## REVIEW OF DETERMINATION ASSESSMENT REPORT

<b>Application Number:</b>	REV2021/0011
----------------------------	--------------

<b>Responsible Officer:</b>	Jordan Davies
<b>Land to be developed (Address):</b>	Lot 189 DP 11162, 129 Upper Clontarf Street SEAFORTH NSW 2092
<b>Proposed Development:</b>	Review of Determination of Application DA2020/0884 for alteration and additions to a dwelling house including a swimming pool
<b>Zoning:</b>	Manly LEP2013 - Land zoned R2 Low Density Residential
<b>Development Permissible:</b>	Yes
<b>Existing Use Rights:</b>	No
<b>Consent Authority:</b>	Northern Beaches Council
<b>Delegation Level:</b>	DDP
<b>Land and Environment Court Action:</b>	No
<b>Owner:</b>	Justin Paul Caruana Rowena Mary Caruana
<b>Applicant:</b>	Justin Paul Caruana

*Figure 1 - View looking south from the top of the existing staircase on the subject site, in the approximate location of the proposed pool. Taken by assessing officer.*

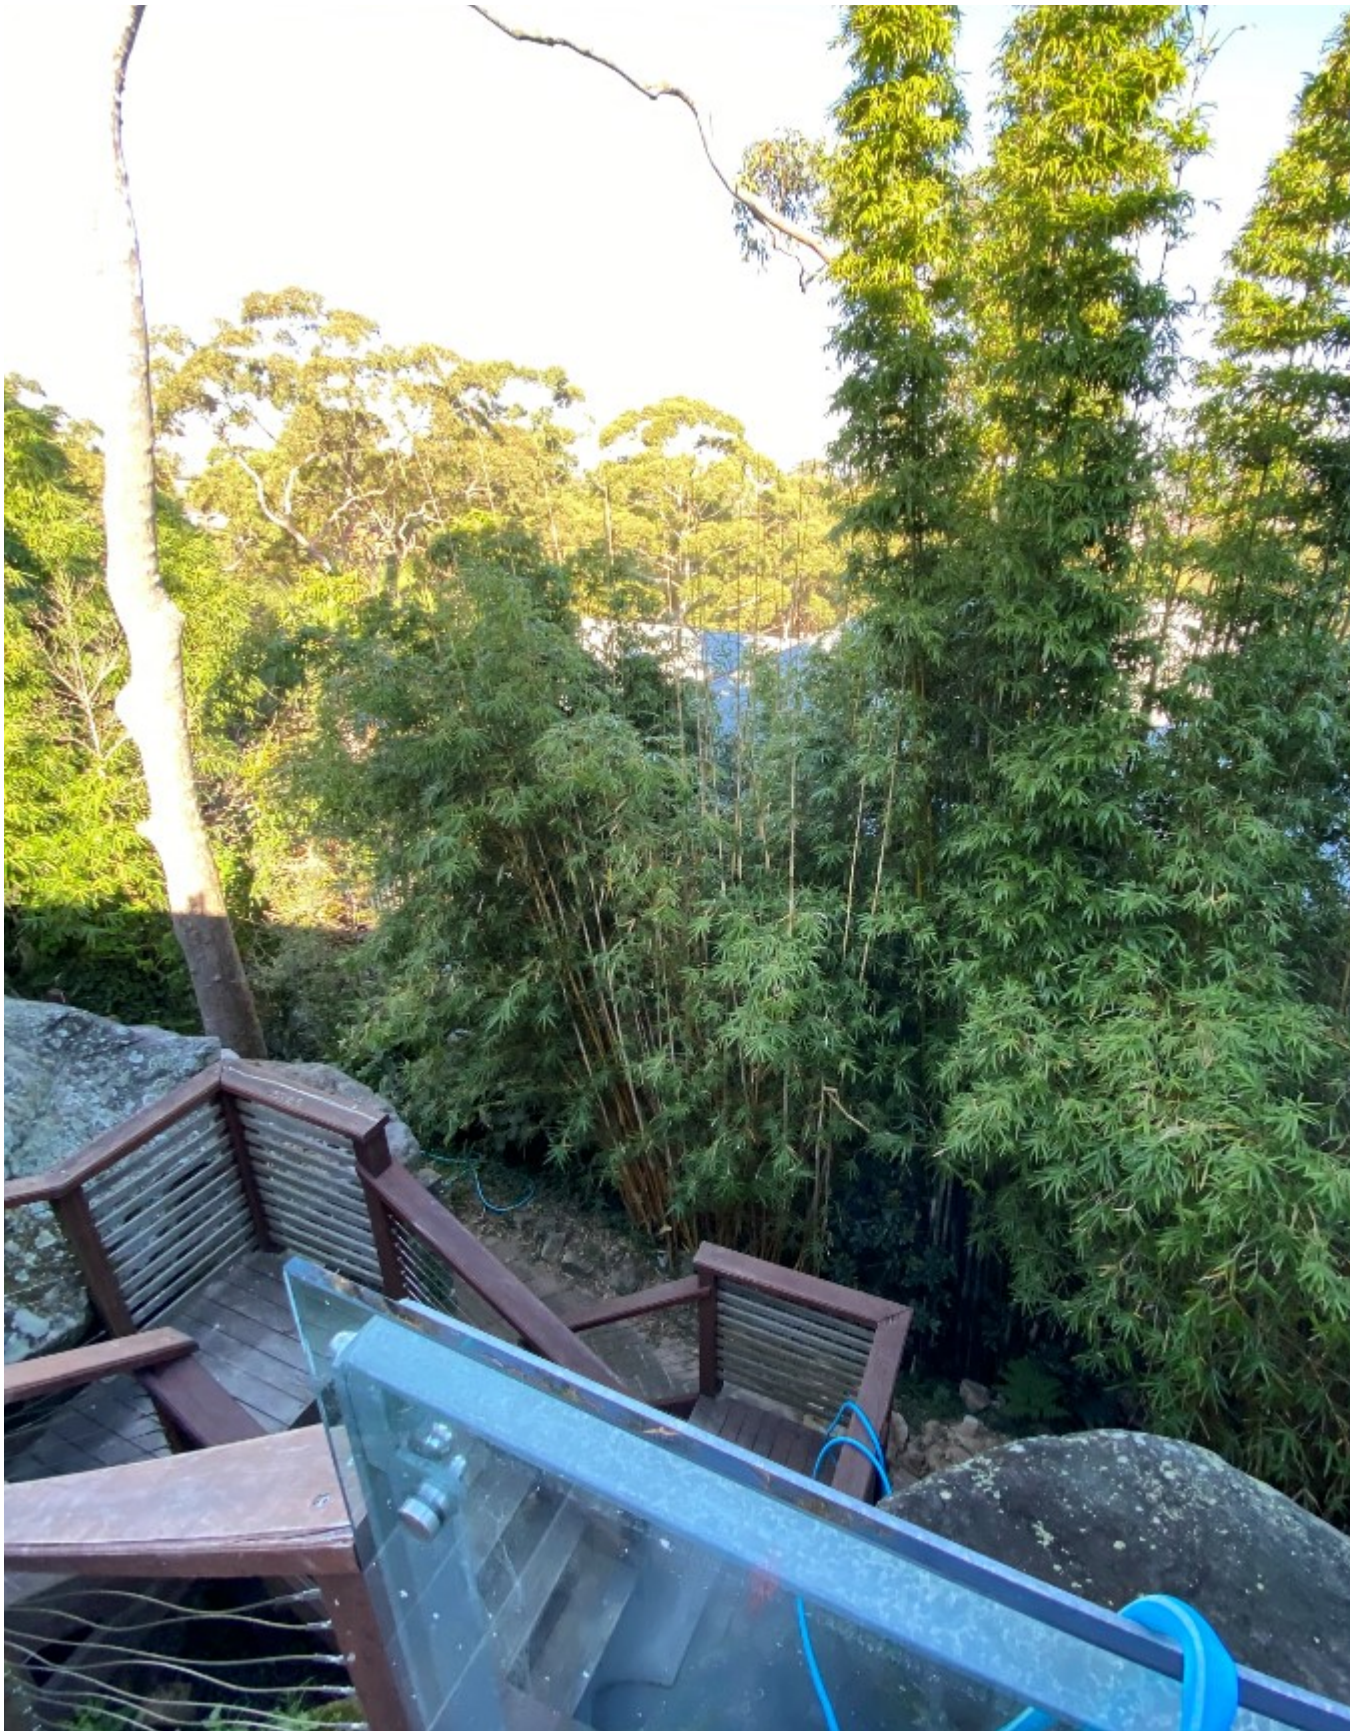
Consideration is given to the visual privacy impact the proposal may have. The proposal does not involve the erection of any new decking areas and provides a very limited pool concourse along the southern edge of the pool (approx 200mm wide), the limited width of the concourse providing a very limited area capable of enabling a person to stand and overlook the adjoining property for anymore than a short period of time (if any).

As shown in the below site photo, there is existing vegetation planting within the subject site along the boundary which provides additional screening between the two properties.
